**From:** Robert Cigale <bob@endpointcorporation.com>  
**Sent:** Monday, March 29, 2021 10:55 AM  
**To:** Grittner, Paul V - DNR  
**Subject:** RE: Klinke Cleaners Fox Run - 02-68-535535  
**Attachments:** FIG D.2\_525-008-006 Barrier Plan-210329.pdf; FIG B.2.c\_525-008-006 Cut Fill Areas-210329.pdf

**CUT / FILL AREAS**

KLINKE CLEANERS - FOX RUN  
 2346 W. ST. PAUL AVENUE  
 WAUKESHA, WISCONSIN 53188

**BARRIER PLAN**

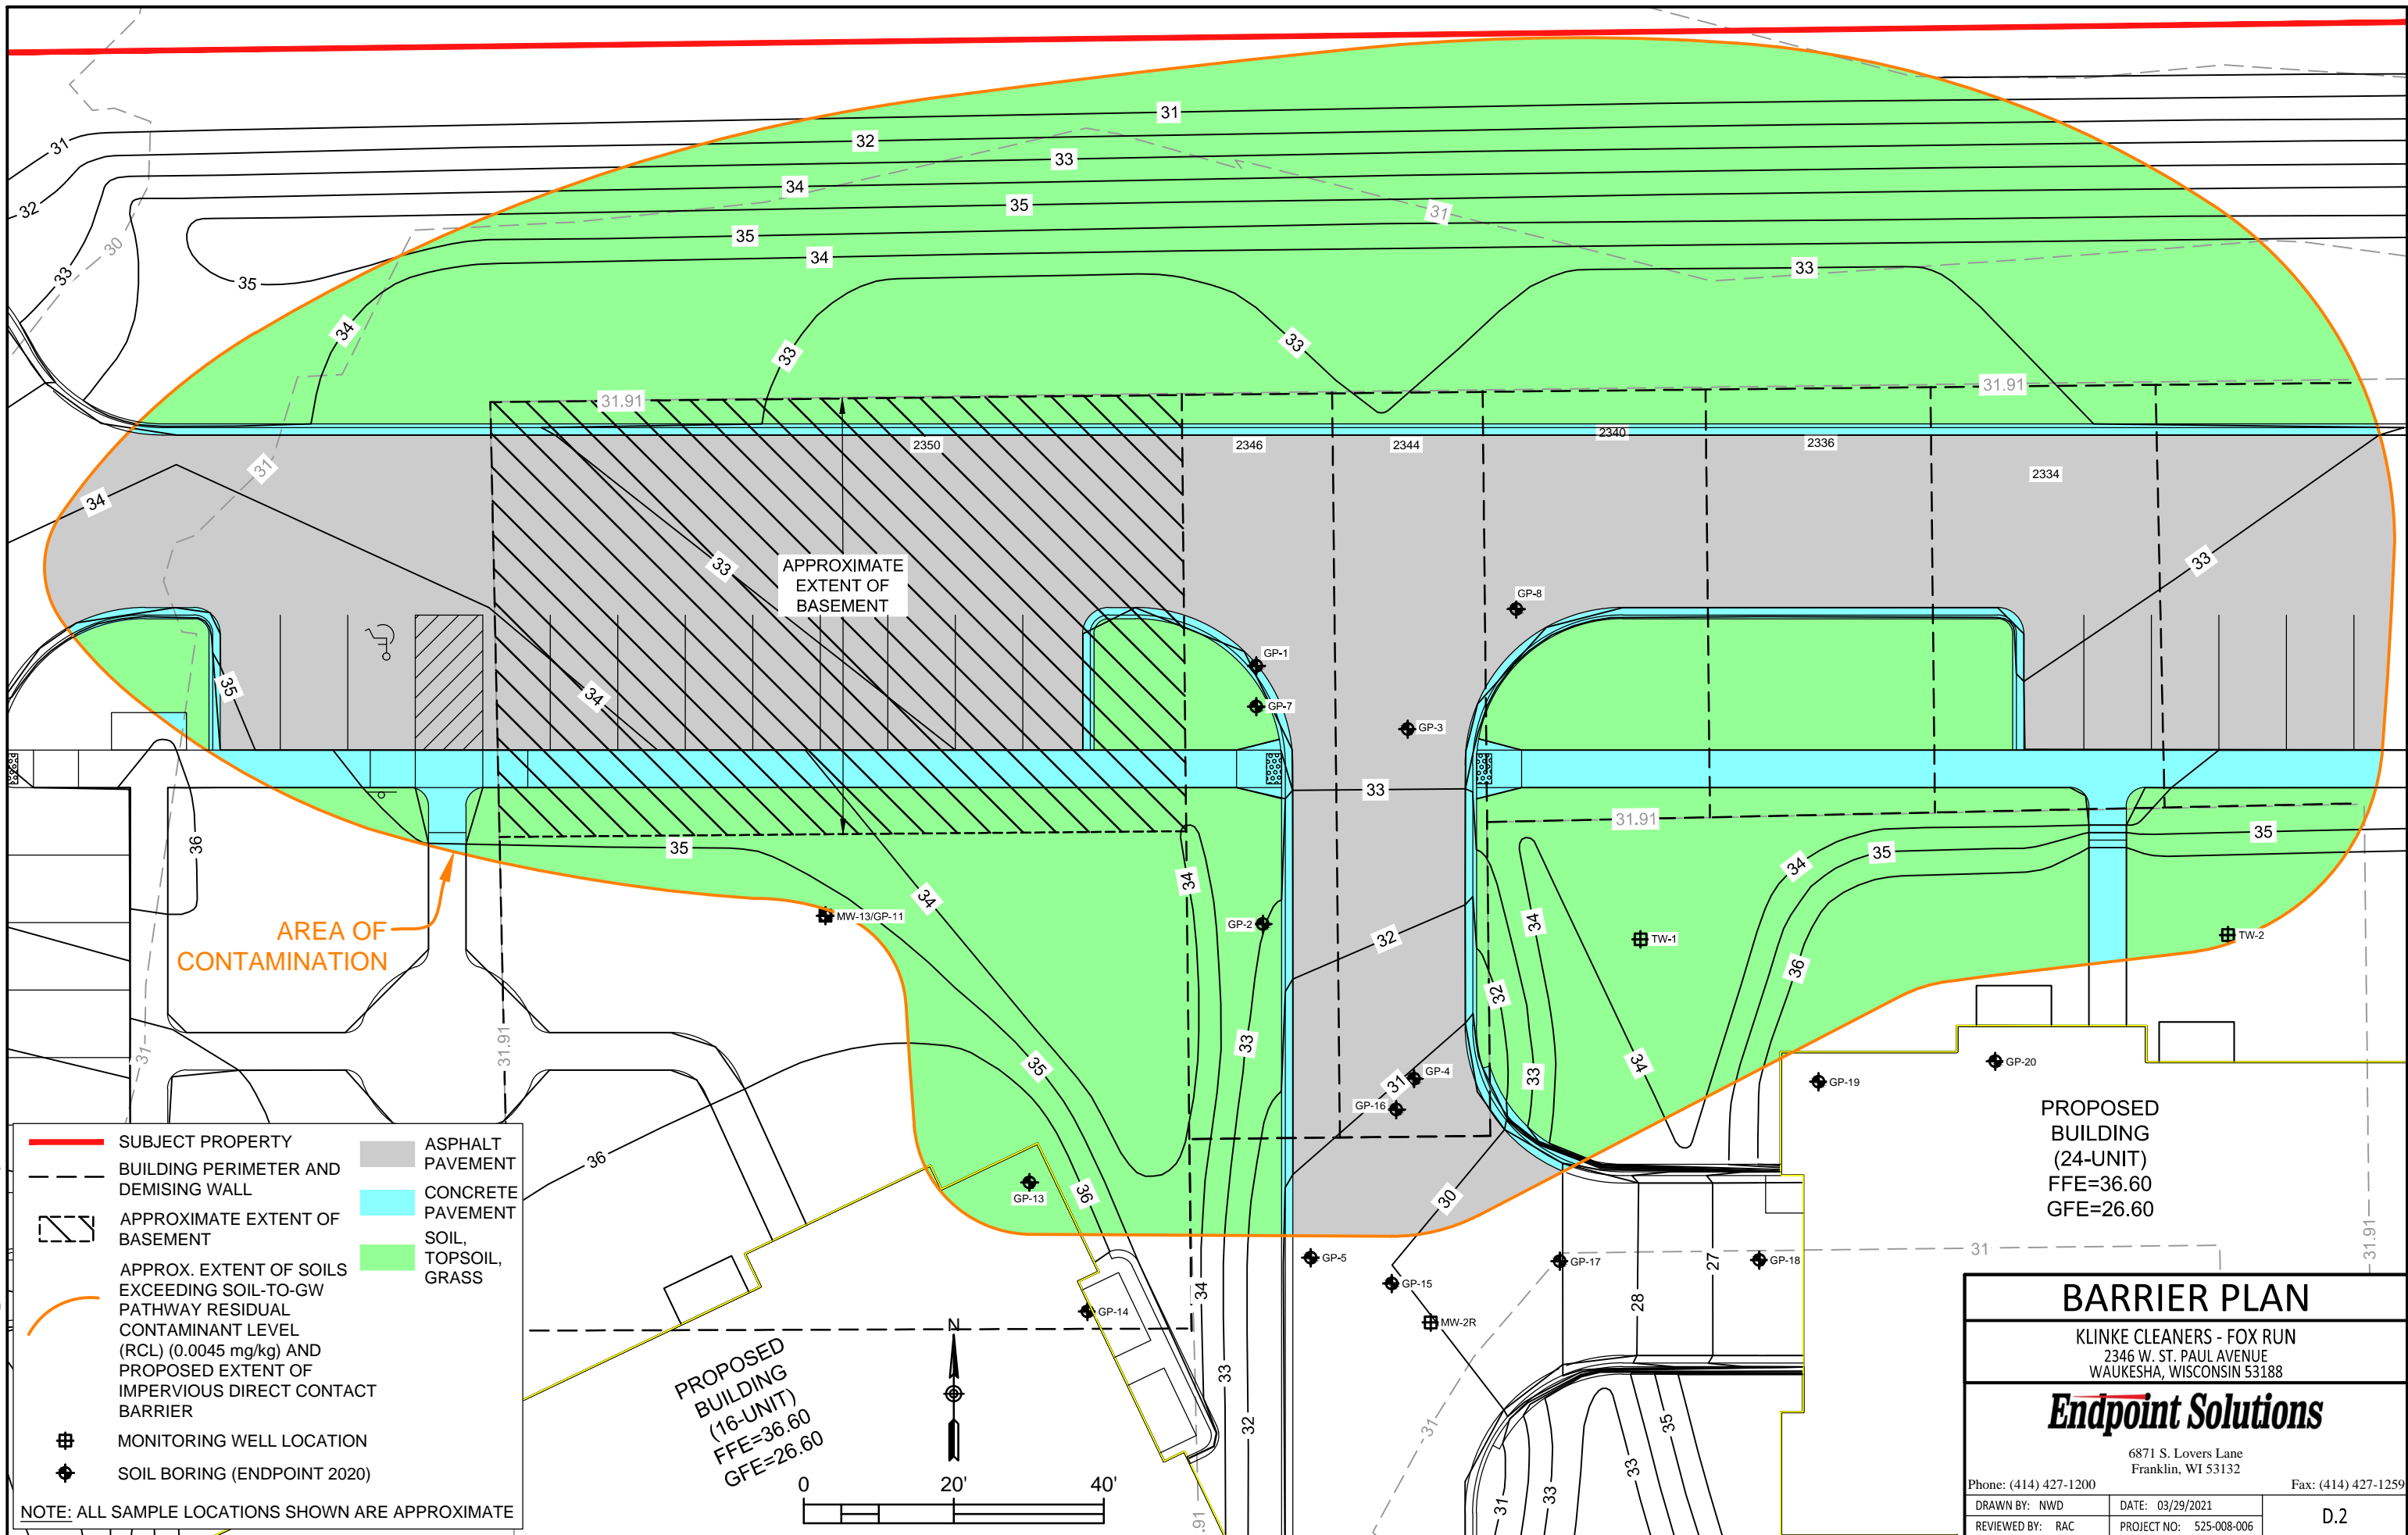
Is the AOC considered the entire area we are defining as the approximate extent of soil to groundwater RCL exceedances, or is the AOC the specific area where the excavated contaminated soils will be consolidated?

We would consider the AOC to be the total area that is contaminated. This could be estimated as the area you already identified where soil contamination exceeds the RCL (the red circled area).
